Current draft footprint

Changes included in this version to allow for new Mill-Max 0851-mod-slim pin

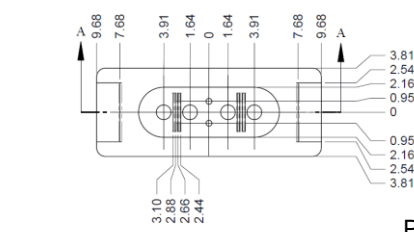
Details Needed

SECTION A-A

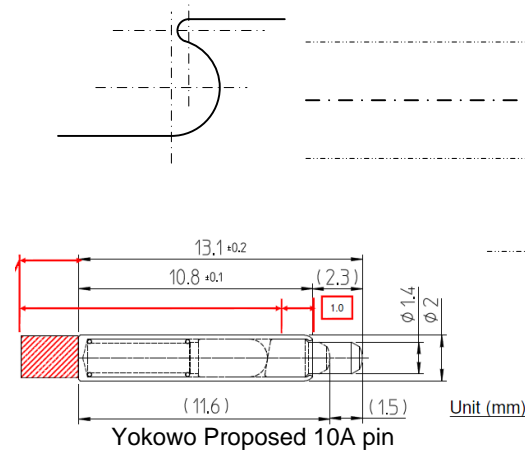
- Move Vneg + 0.25mm to 1.9mm from C/L
- Move Vpos-Vneg to 2.54+0.26 = 2.8mm
- Vpos - C/L = 2.8mm+1.9mm = 4.7mm
- Optical C/L to connector C/L = 1.9 + 1.4 = 3.3mm
- Overall pin dimension length changed is 1.58mm
